10 Minshull Street and 11 Bloom Street

FLOOR BUILD UP, SHADOW GAP DETAIL BREAKDOWN

PLANNING CONDITIONS RELEASE 11(d)

Planning Permission 119374/FO/2018 – BOTH BUILDINGS

Figure 1 Party wall head detail

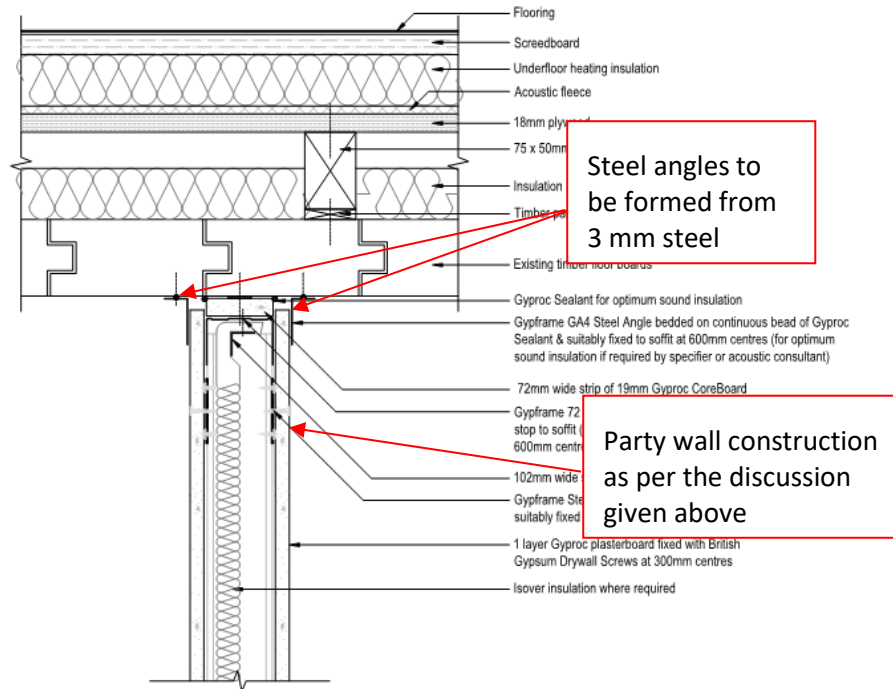
A bulkhead detail was previously recommended in memo M003-A in order to control noise transfer via the head at the partition where it interfaces with the existing timber floor. As noted above, the conservation officer has deemed this to be unacceptable.

Without the bulkhead, there is a risk that the weakness at the exposed partition head would reduce the laboratory to site tolerance of the partition and limit the overall performance of the partition. The following measures are therefore recommended to provide the highest practicable sound insulation to the separating partitions without the installation of bulkheads:

- Provide a party wall construction with a minimum zone of 250 mm as discussed above
- Provide 3 mm steel angles at the head of the partition as shown in Figure 1.

- Provide an enhanced party wall construction with an overall zone of 250 mm
- Provide 3 mm steel angles to both sides of the party walls at the head
- Support the floor battens on a resilient cradle/strip and provide a resilient flanking strip at the edge of each floated floor.

Figure 1 Excerpt of drawing 061_508_SHADOW GAP DETAIL_20.08.21 – Separating partition interface with external wall

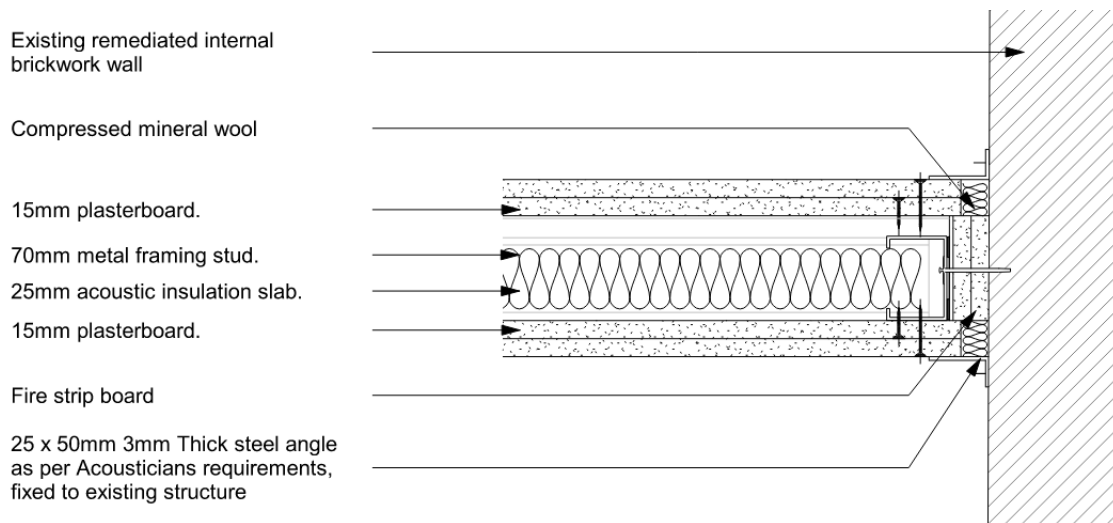
The external wall interface uses a deflection detail with 3 mm steel angles covering the joint, as shown below in Figure 1. This is expected to be suitable provided it is well sealed based on the facade comprising a minimum of 200 mm solid brickwork.

Figure 2 Excerpt from drawing 061_508_SHADOW GAP DETAIL_20.08.21 – a separating partition head detail

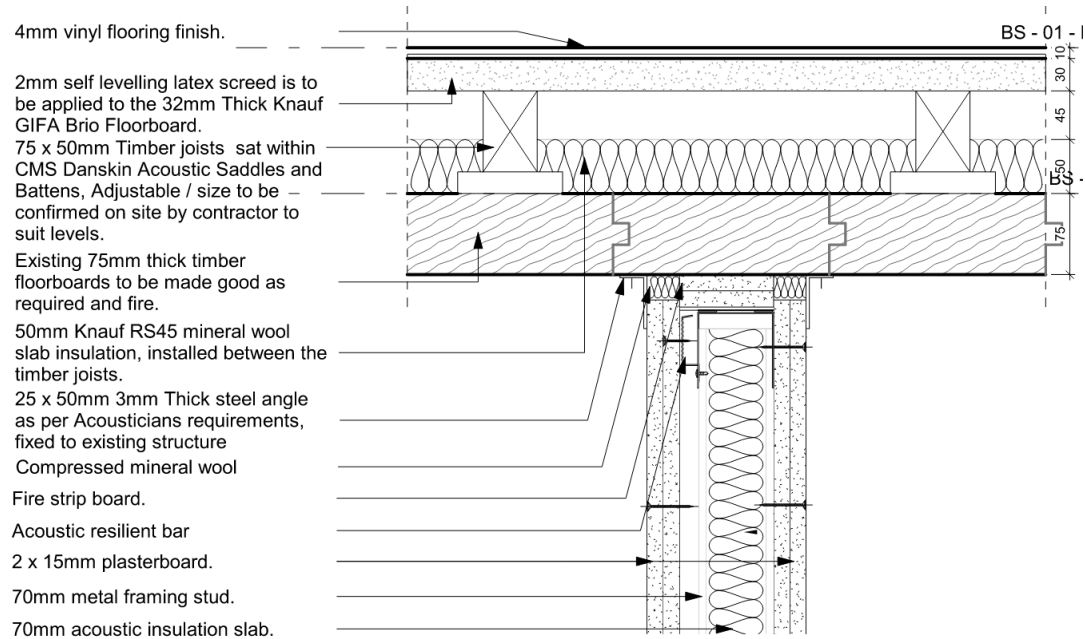
The head detail for the separating partition is a similar deflection detail with metal angles covering the gap. This is expected to be suitable in itself, however, flanking sound transmission via the floorboards is a significant concern, limiting of the separating partition sound insulation performance to around $D_{nT,w} + C_{tr}$ 40 dB.

One of the following options should be adopted if possible:

- Provide a suspended ceiling consisting of 2 x 12.5 mm standard plasterboard or equivalent to both sides or a structural break in the floorboards.
- It is understood to be the intention to expose the underside of floorboards. If this is the case there would need to be a structural break in the floorboards which does not compromise the vertical sound insulation.
- Provide a bulkhead either side of the partition comprising 2x15 mm dense plasterboard, 50 mineral fibre within the bulkhead (minimum density 30 kg/m³) and extend at least 300 mm either side of the party wall and 300 mm below the existing floorboards.

Figure 4 Excerpt from drawing 013-MDB-BS-ZZ-DT-A-2201 – Separating partition base detail

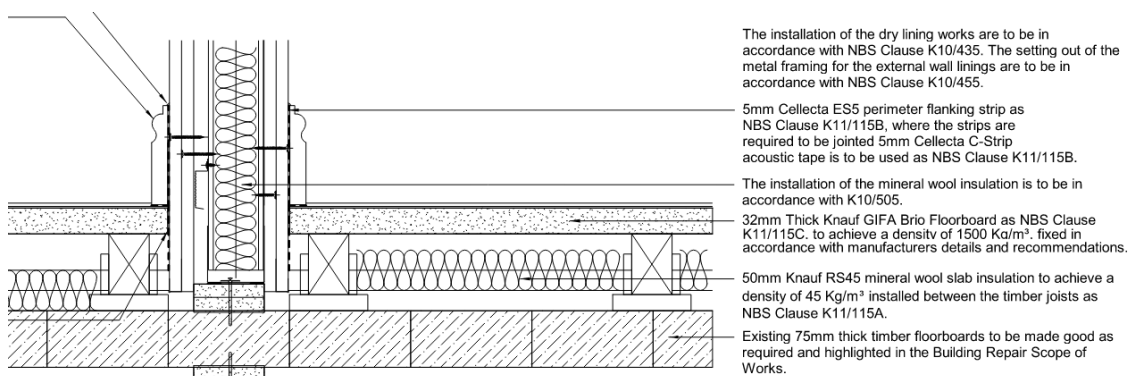
The base detail for the party wall as shown in Figure 4 looks to suitably control flanking sound transmission, provided that the flanking strips are installed correctly and also installed around any other elements which are connected to the structural floor.

Figure 5 Excerpt of drawing 013-MDB-BS-ZZ-DT-A-2201 – Separating floor interface with external wall

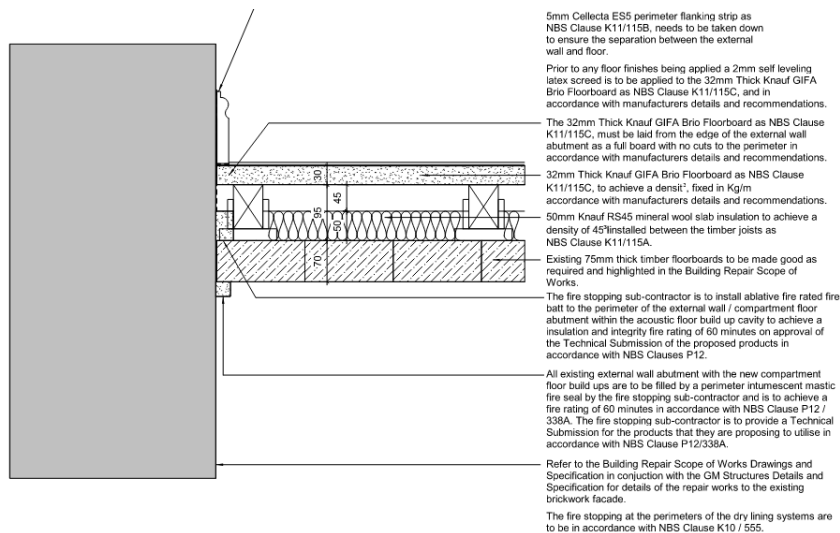
As the floor is of lightweight construction, the interface with the external wall as shown in Figure 5 is expected to be suitable provided any gaps for structural elements are well sealed.

Figure 6 Excerpt of drawing 013-MDB-BS-ZZ-DT-A-2200 – Separating partition interface with curtail walling

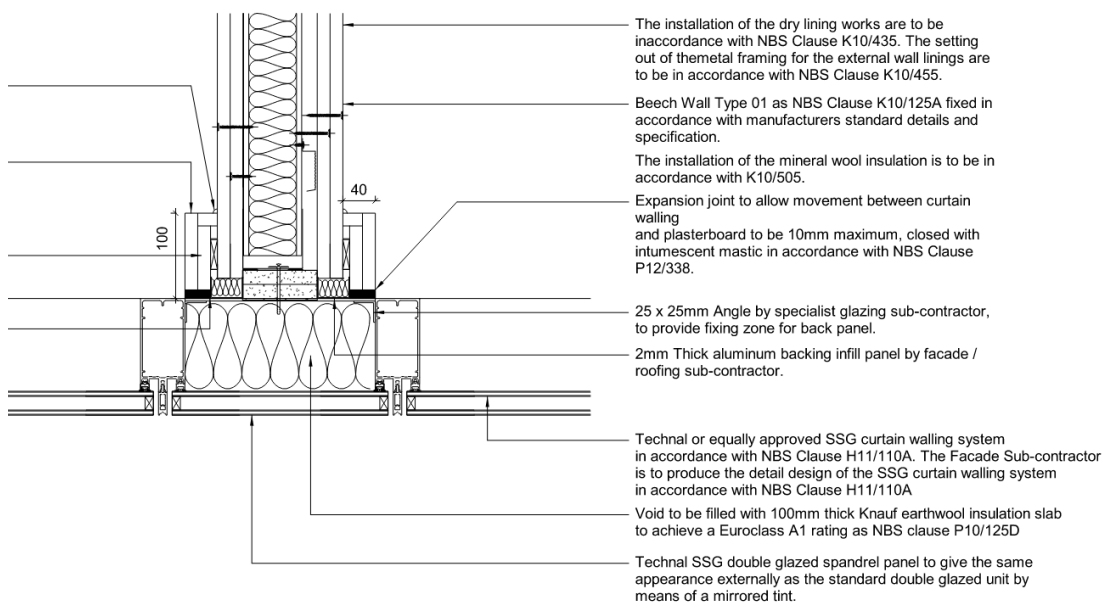
The proposed interface with the curtain wall as shown in Figure 6 is expected to be borderline with the requirements for separating partitions. It is recommended that the overboarding extends to cover the mullions. Alternatively, metal over cladding of equivalent surface density could be used to improve the flanking sound transmission performance.

Figure 2 Excerpt from drawing 013-MDB-BS-ZZ-DT-A-2200– a separating partition head and base detail

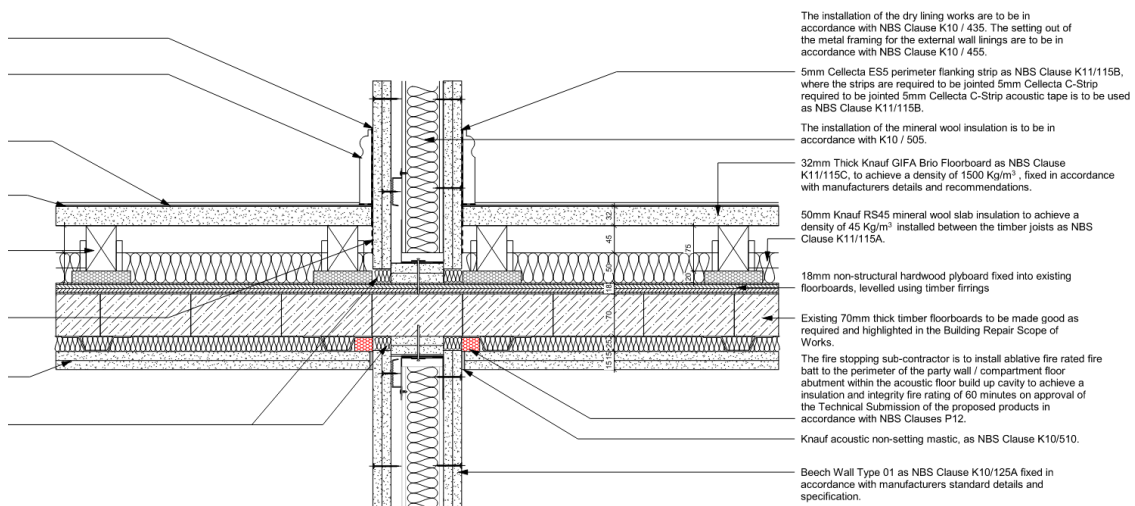
The head detail for the separating partition is a deflection detail with a double plasterboard ceiling to both sides. This is expected to be suitable in itself. The base detail is also expected to

be suitable provided flanking strips are installed correctly and also installed around any other elements which are connected to the structural floor.

Figure 3 Excerpt of drawing 013-MDB-BS-ZZ-DT-A-2201 – Separating floor interface with external wall

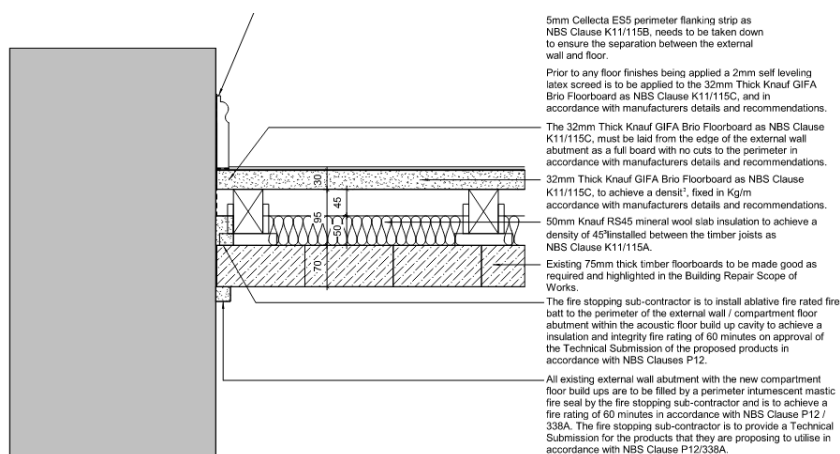
As the floor is of lightweight construction, the interface with the external wall as shown in Figure 3 is expected to be suitable provided any gaps for structural elements are well sealed.

Figure 4 Excerpt of drawing 013-MDB-BS-ZZ-DT-A-2200 – Separating partition interface with curtail walling

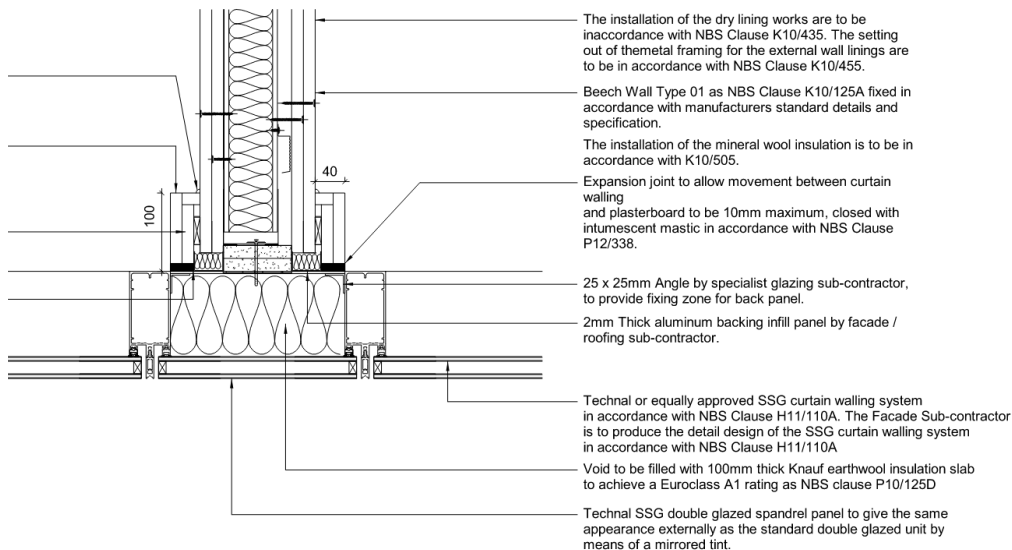
The proposed interface with the curtain wall as shown in Figure 4 is expected to be borderline with the requirements for separating partitions.

Given that both buildings are listed, this performance may be acceptable given the control of other flanking elements. However, given this is a new-build element it is recommended that the overboarding extends to cover the mullions. Alternatively, metal over cladding of equivalent surface density could be used to improve the flanking sound transmission performance.

Figure 2 Excerpt from drawing 013-MDB-BS-ZZ-DT-A-2200– a separating partition head and base detail

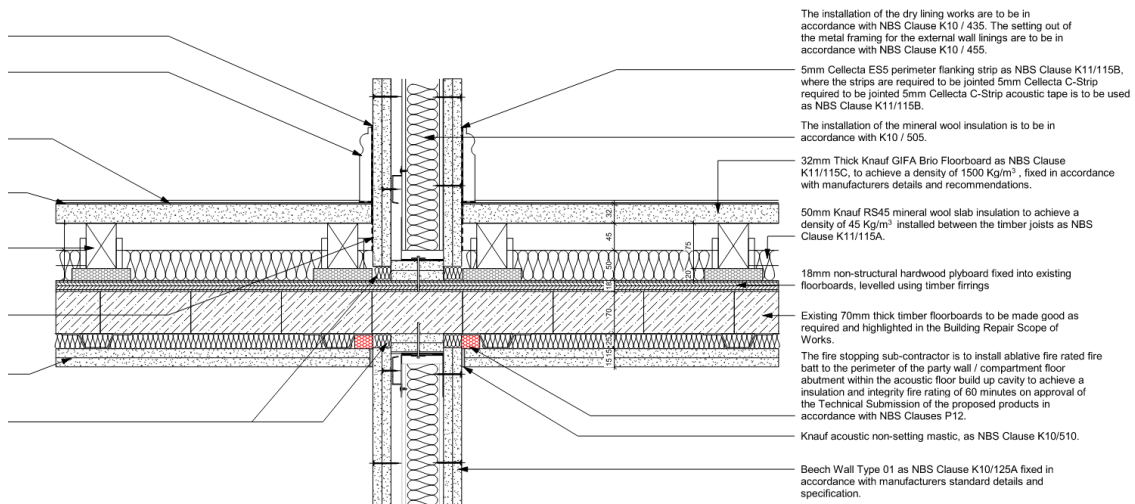
The head detail for the separating partition is a deflection detail with a double plasterboard ceiling to both sides. This is expected to be suitable as shown.

If the plasterboard ceiling is omitted, ideally the deflection detail should be covered by metal angles. However, there is significant tolerance within the partition performance itself to allow a reduced flanking performance at the head detail for twin-stud partitions.

The base detail is also expected to be suitable provided flanking strips are installed correctly and also installed around any other elements which are connected to the structural floor. Steel angles to the base detail would not be necessary.

Figure 3 Excerpt of drawing 013-MDB-BS-ZZ-DT-A-2201 – Separating floor interface with external wall

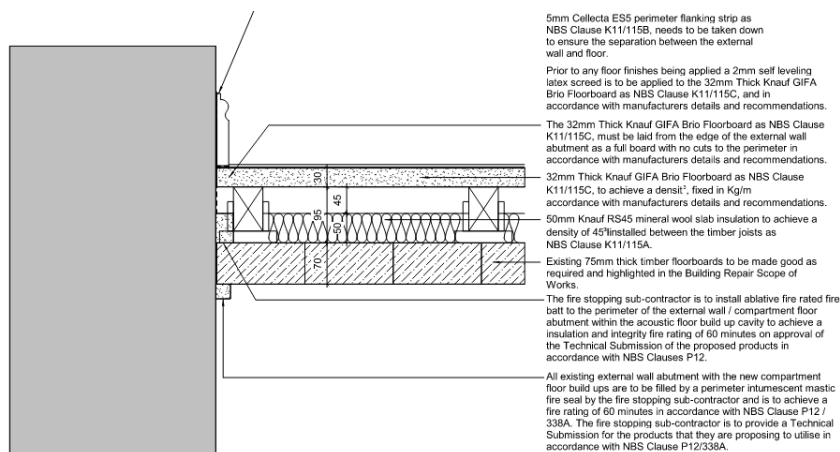
As the floor is of lightweight construction, the interface with the external wall as shown in Figure 3 is expected to be suitable provided any gaps for structural elements are well sealed.

Figure 4 Excerpt of drawing 013-MDB-BS-ZZ-DT-A-2200 – Separating partition interface with curtail walling

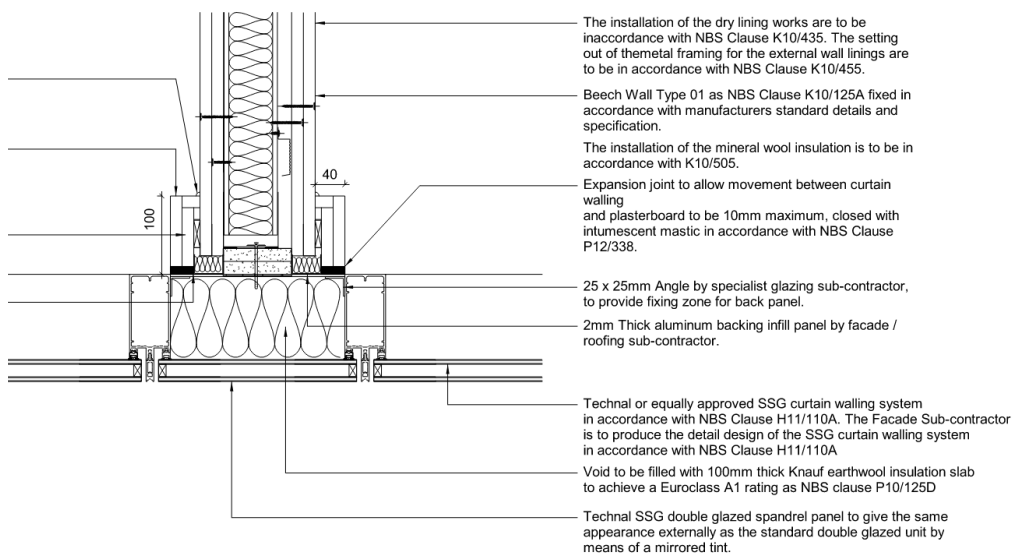
The proposed interface with the curtain wall as shown in Figure 4 is expected to be borderline with the requirements for separating partitions.

Given that both buildings are listed, this performance may be acceptable given the control of other flanking elements. However, given this is a new-build element it is recommended that the overboarding extends to cover the mullions. Alternatively, metal over cladding of equivalent surface density could be used to improve the flanking sound transmission performance.

Figure 3 Excerpt of drawing 013-MDB-BS-ZZ-DT-A-2201 – Separating floor interface with external wall

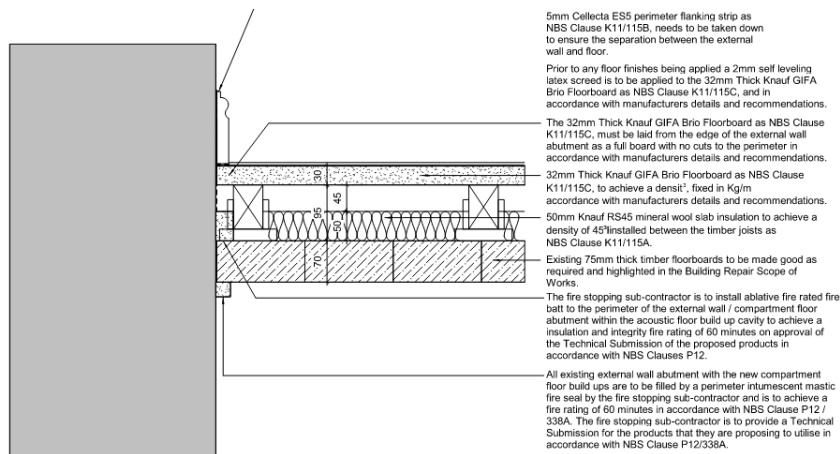
As the floor is of lightweight construction, the interface with the external wall as shown in Figure 3 is expected to be suitable provided any gaps for structural elements are well sealed.

Figure 4 Excerpt of drawing 013-MDB-BS-ZZ-DT-A-2200 – Separating partition interface with curtail walling

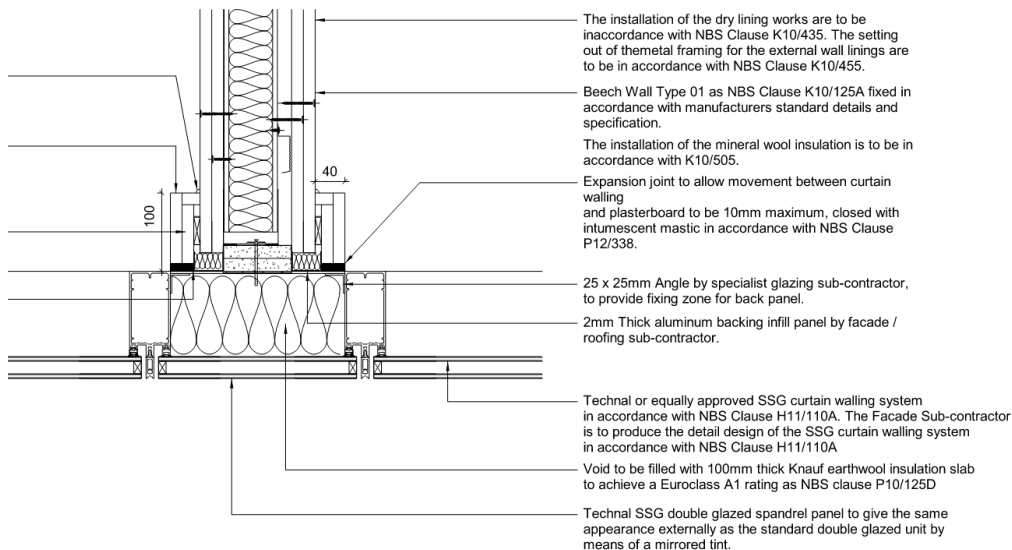
The proposed interface with the curtain wall as shown in Figure 4 is expected to be borderline with the requirements for separating partitions.

Given that both buildings are listed, this performance may be acceptable given the control of other flanking elements. However, given this is a new-build element it is recommended that the overboarding extends to cover the mullions. Alternatively, metal over cladding of equivalent surface density could be used to improve the flanking sound transmission performance.
